SUBJECT: River Bend Station, Unit 1
Docket No. 50-458
Supplement to Amendment Request
License Amendment Request (LAR) 2001-027, Emergency Diesel
Generator Extended Allowed Outage Time, TS 3.8.1.

**Response to Request for Additional Information Related to
License Amendment Request (LAR) 2001-027,
EDG Extended AOT**

RBS Monthly Average CDF Graph (Nov. 1997 ~ Dec. 2000)

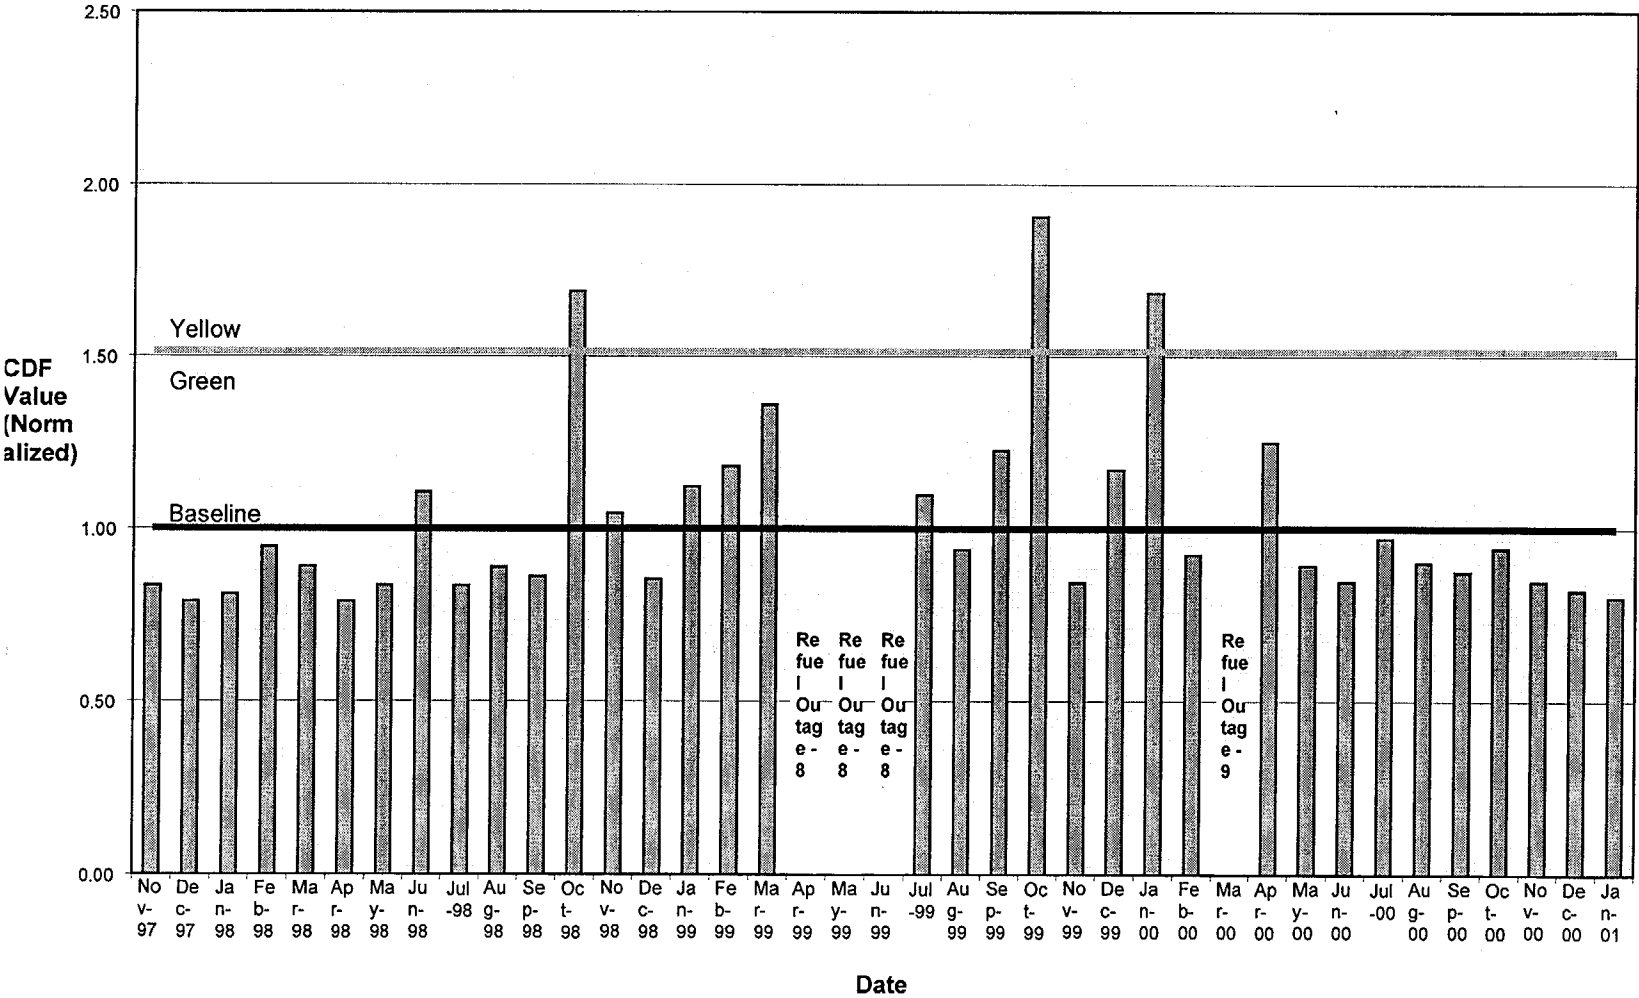
The RBS monthly CDF graph is included as Figure 1. The monthly CDF values were normalized with the RBS Level 1 Rev 3 baseline CDF value. Both baseline CDF and the Green/Yellow transition CDF values are shown on the graph. Note that the CDF values were not calculated during refueling outages. The CDF values should be calculated based on the RBS Level 1 Shutdown EOOS model. For simplicity, these values are not listed here.

The ΔCDF values of all three cases exceed the maximum percent change in permanent CDF considered to be Non-Risk-Significant (32.5% for the baseline CDF value of $9.446\text{E-}6/\text{yr}$ for RBS Level 1 Rev 3 PRA). However, even for the highest CDF change in Oct. 1999, the change in CDP in that month is $(1.801\text{E-}5 - 7.15\text{E-}6)/\text{yr} * 1\text{yr}/12 = 9.05\text{E-}7$, which is acceptable according to the Quantitative Screening Criteria for Temporary Changes based on CDP values in the EPRI PSA Application Guide (TR-105396). Therefore, it is concluded that the risk

Figure 2
1998 Year-to-Date Cumulative CDP

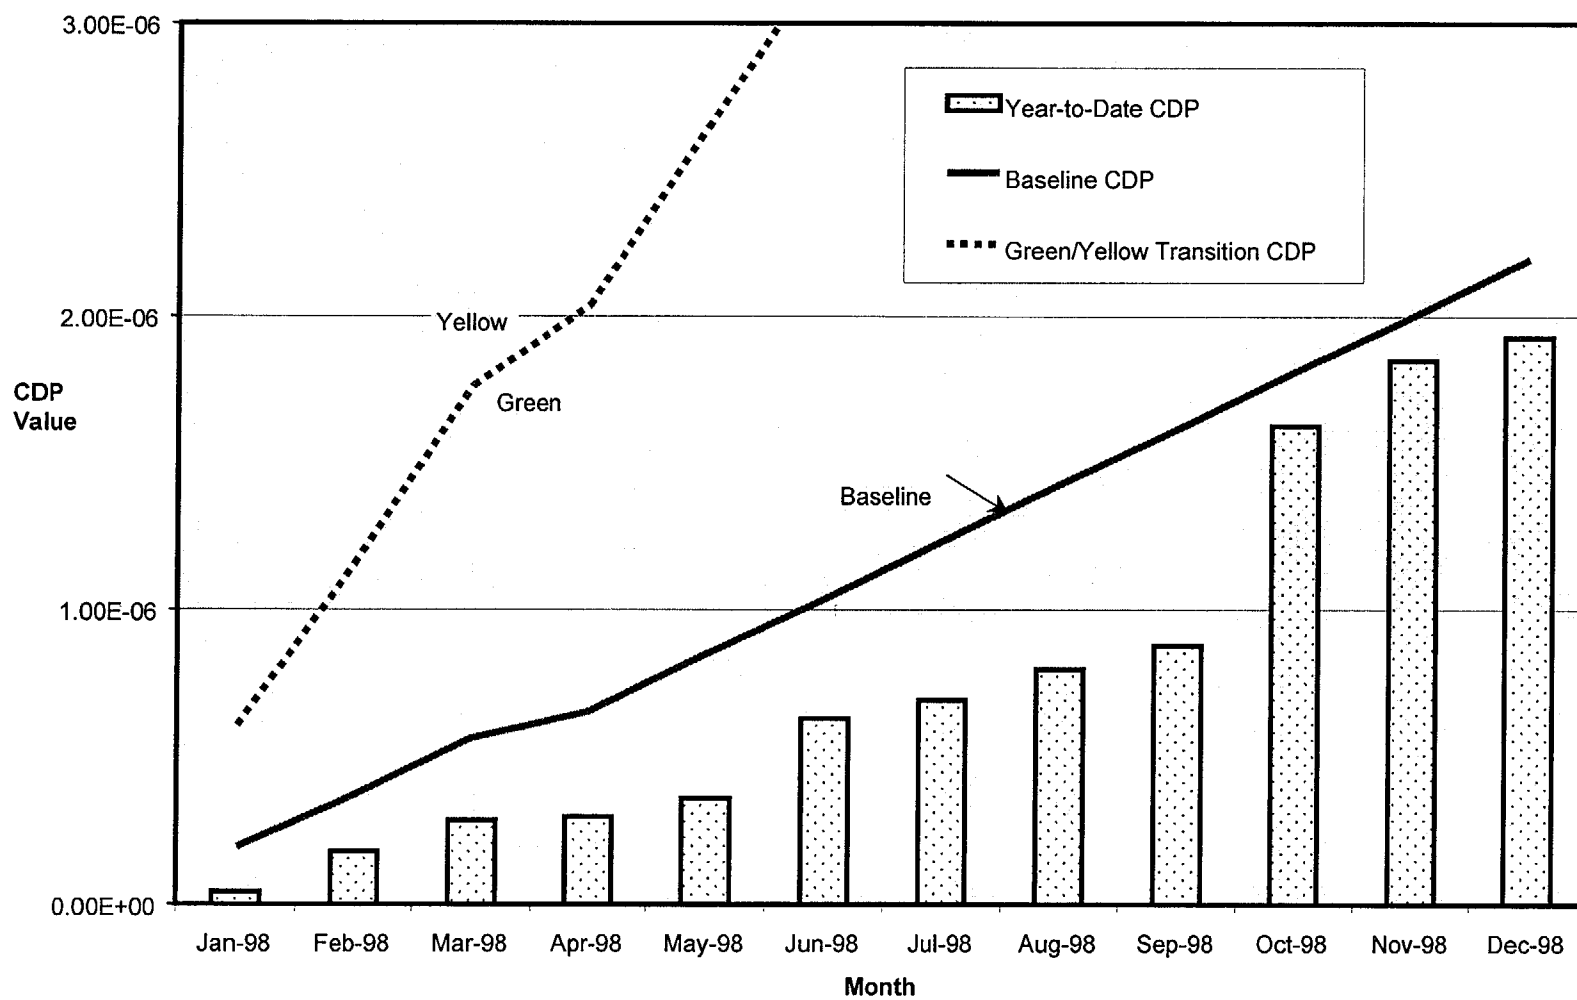
Figure 2 shows the year-to-date cumulative CDP plots for the past three years (1998 to 2000). These figures show the cumulative plant risk over time on a yearly basis and how this relates to the baseline CDP and the CDP values corresponding to the Green/Yellow transition CDF value in EOOS. Since no monthly CDF was calculated for refueling outage months, the cumulative CDP values did not include those months also.

The cumulative risk profile in 1998 shows that the year-to-date CDP values were always below the baseline CDP. And the 1999 cumulative risk profile shows that the year-to-date CDP values were always above the baseline CDP's. However, it should also be noted that the CDP values were still well below the Green/Yellow transition lines. For the 2000 cumulative risk profile, although the figure shows the plant year-to-date CDP values were above the baseline CDP for most of the months, the final CDP value for 2000 was actually lower than the baseline value. It was the higher monthly CDF value in January 2000 that raised the CDP values significantly. As discussed in the previous section based on the monthly averaged CDF values, the risk changes in the past three years were Non-Risk-Significant.

Figure 4
2000 Year-to-Date Cumulative CDP

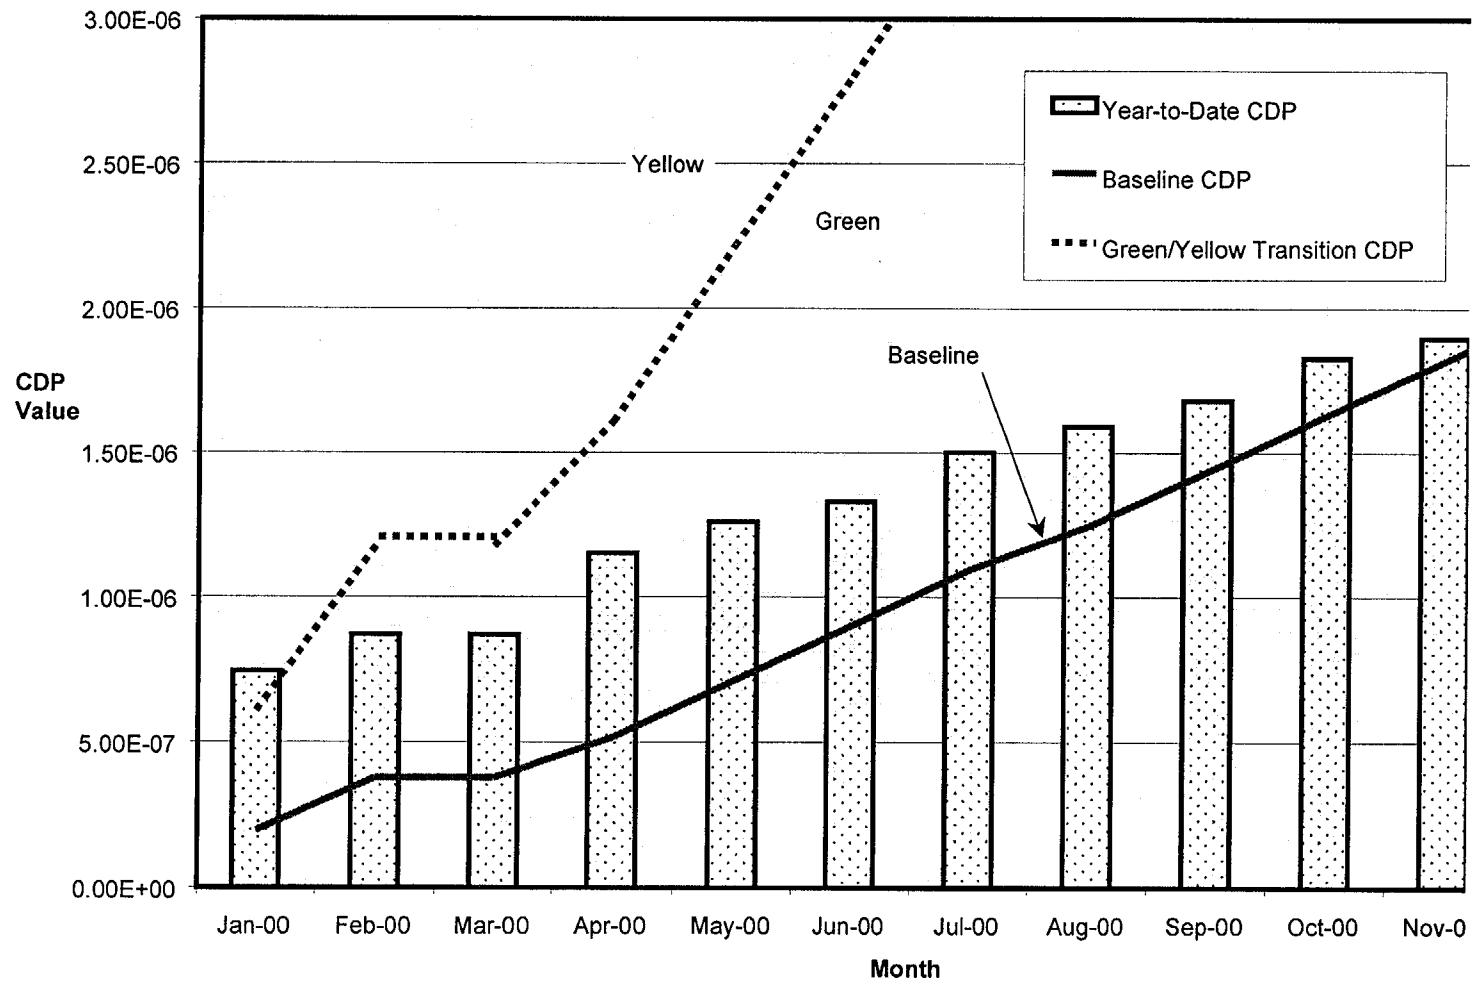
These values are at the baseline risk level and within the Non-Risk-Significant range per PSA Application Guide. The Level 1 Rev. 3 PRA model was used in producing the risk profiles, which should reflect the plant conditions in the past three years most accurately. Although the CDF values were increased due to the PRA model update, there is no sustained trend evident in the monthly averaged CDF and the year-to-date CDP graphs.
